Amend 97-0807

APPLICATION FOR AMENDMENT TO PERMIT

Location 117 Winter St Within Fire Limits? \_\_\_\_\_ Dist. No. \_\_\_\_\_
Owner's name and address Zanoni, Mary Clews, Henry Telephone \_\_\_\_\_
Lessee's name and address \_\_\_\_\_ Telephone \_\_\_\_\_
Contractor's name and address Henry Clews Telephone \_\_\_\_\_
Architect 119 Winter St Portland, ME 04102 Plans filed \_\_\_\_\_ No. of sheets \_\_\_\_\_
Proposed use of building 772-3299 No. families \_\_\_\_\_
Last use 5-fam to 4-fam New 5 Family No. families \_\_\_\_\_
Increased cost of work 5,000.00 Additional fee 50.00

Request to alter building plan at  
117 Winter St 2nd floor  
1/4" = 1'-0"

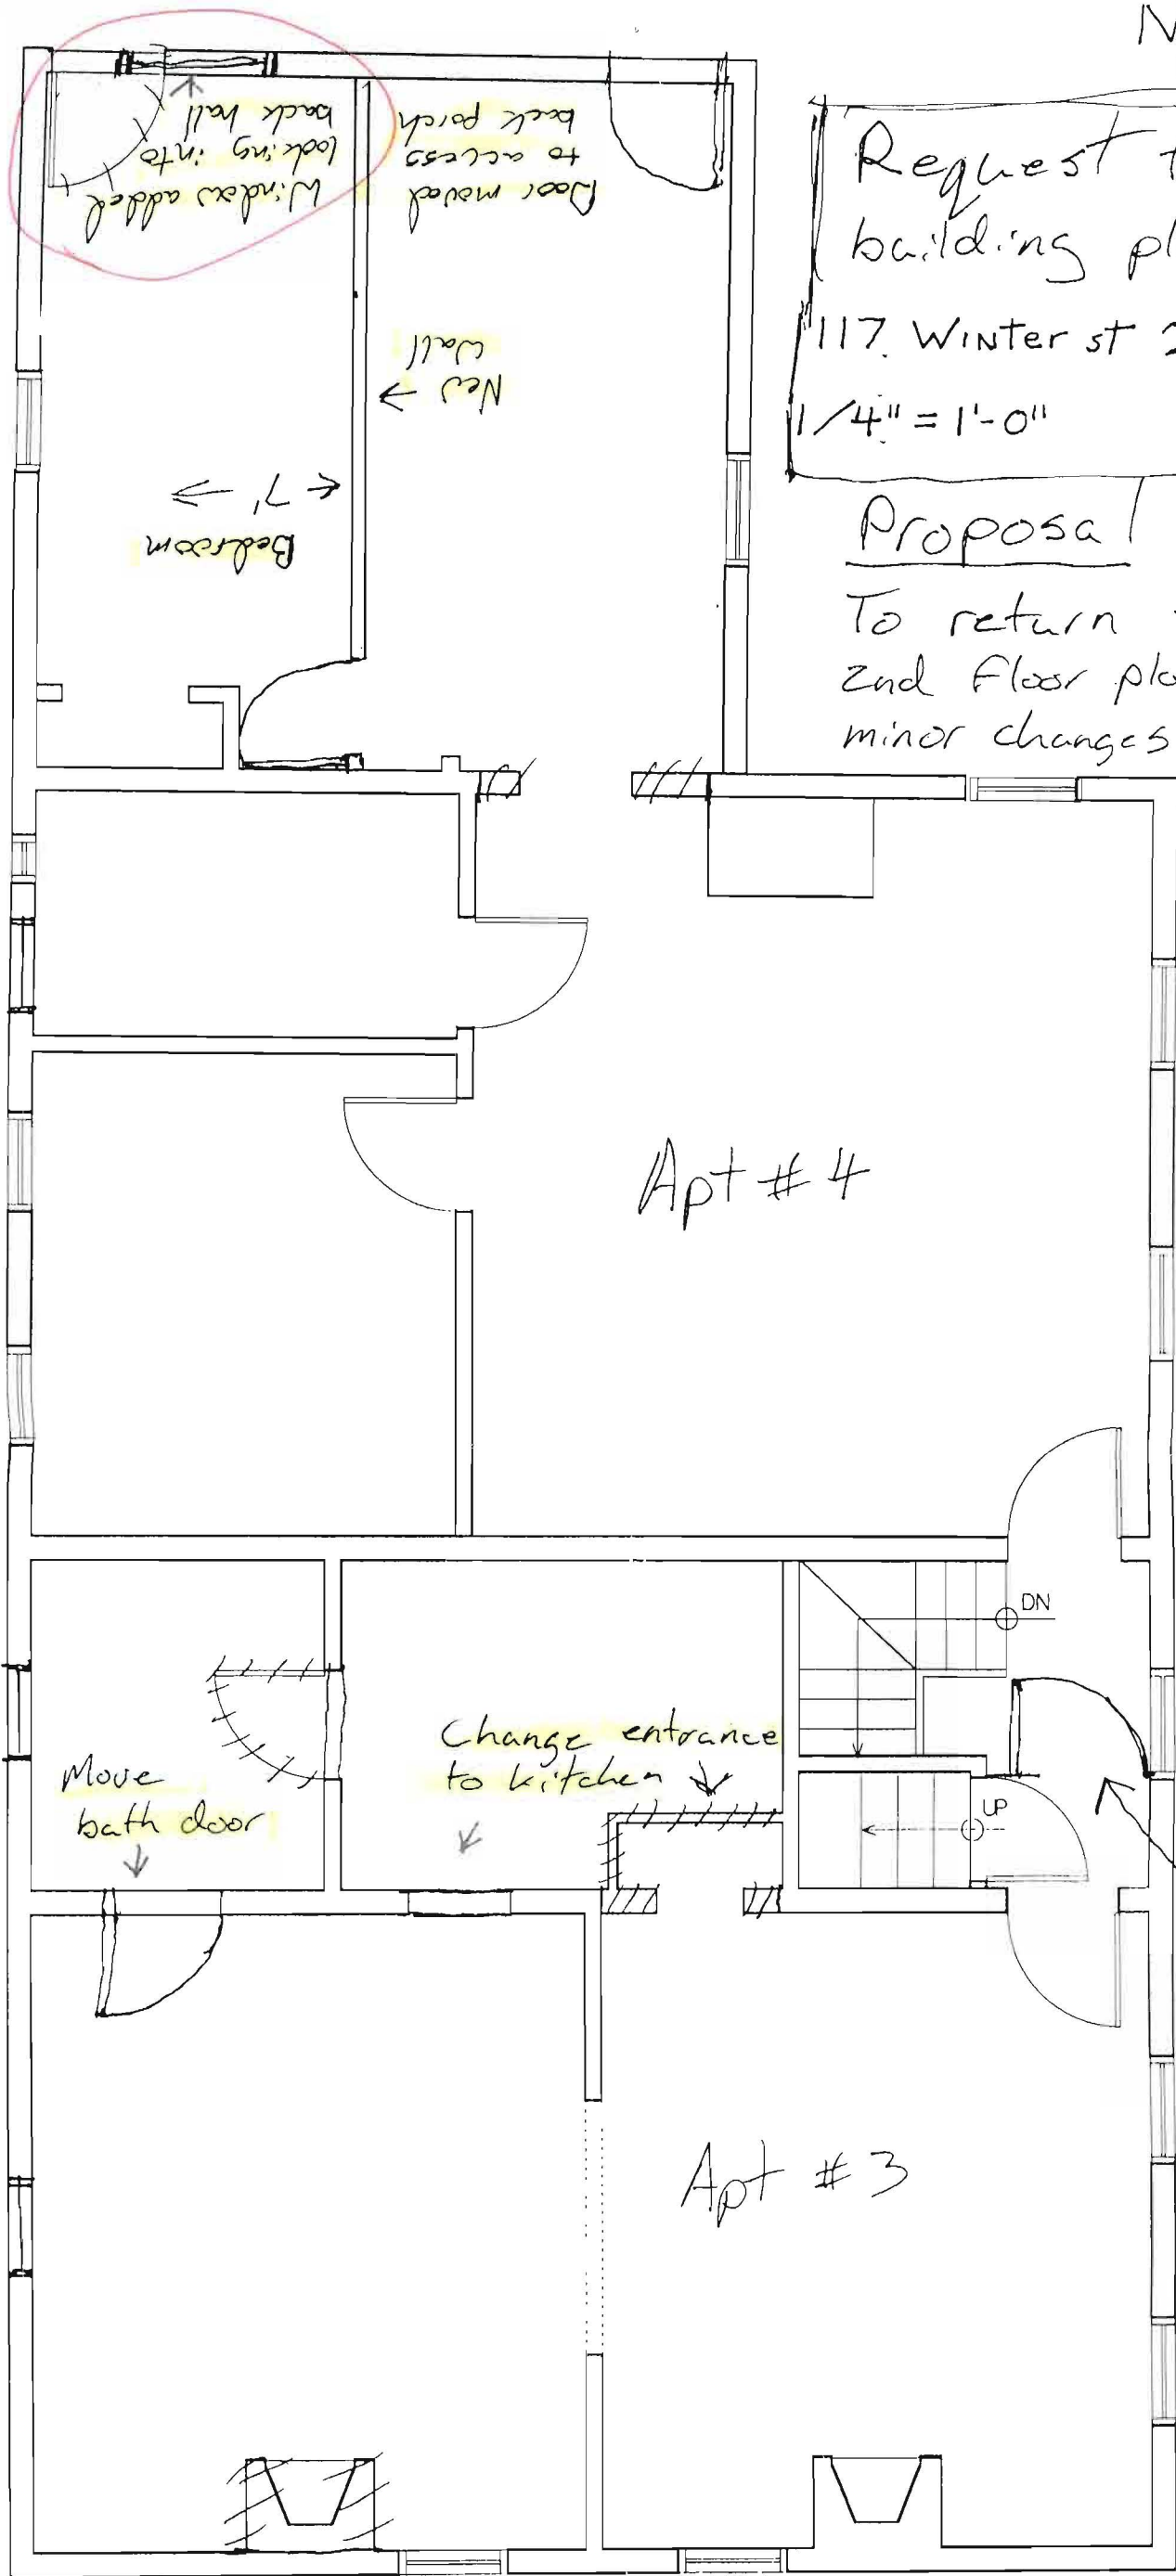
To return to original 2nd floor plan w/ only minor changes to 2nd floor as shown, thus keeping building as a 5 unit as original.

Temporary Plan  
Connect Apt #3 + Apt #5 by installation of fire door in second floor hall until an appropriate 2nd egress for Apt #5 can be constructed

Move bath door  
↓

Change entrance to kitchen  
↓

117 Winter st.

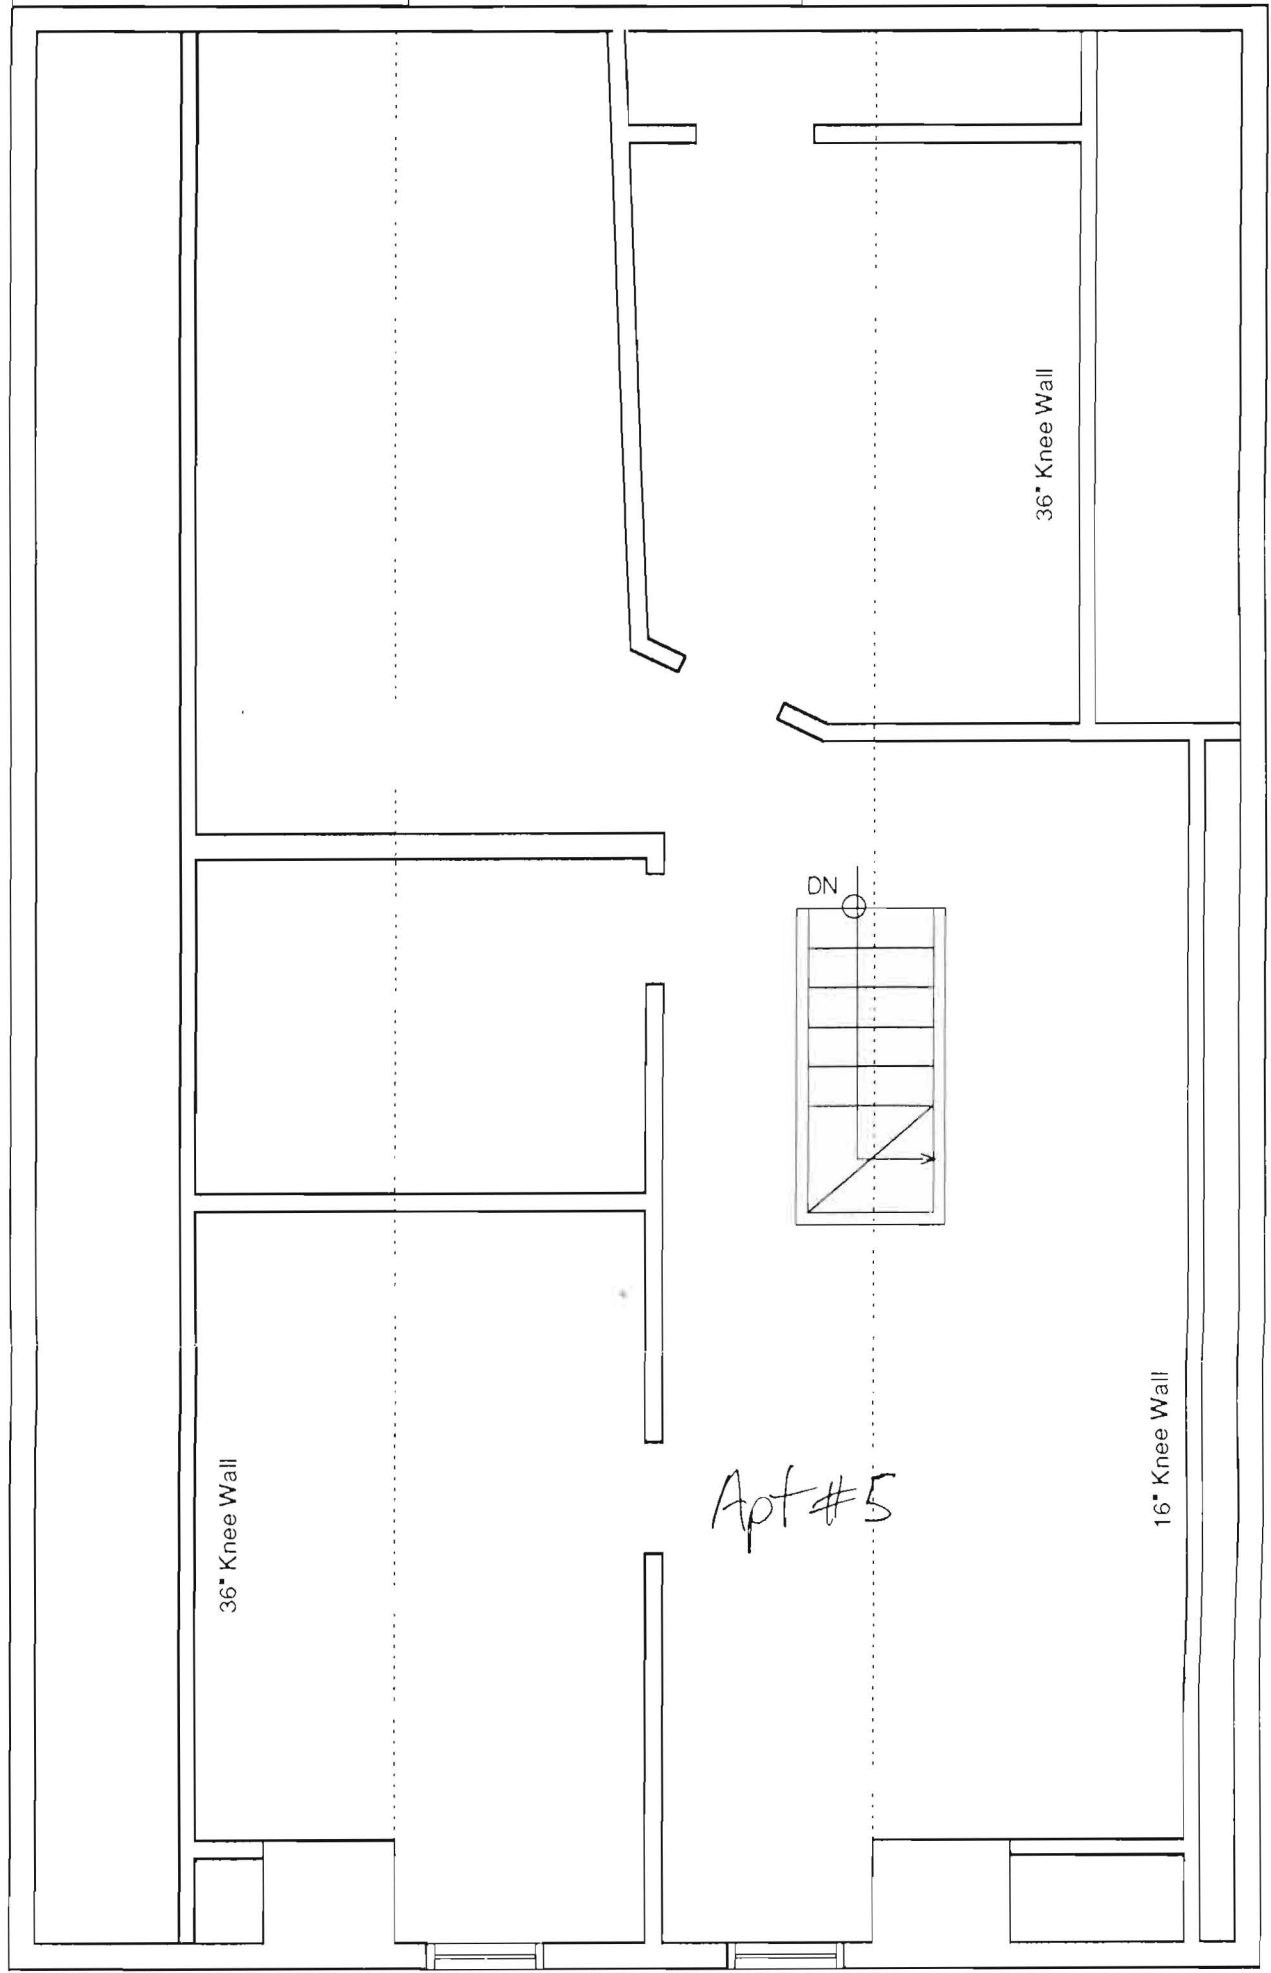
Windows added looking into back wall

Door moved to access back porch

New wall  
←
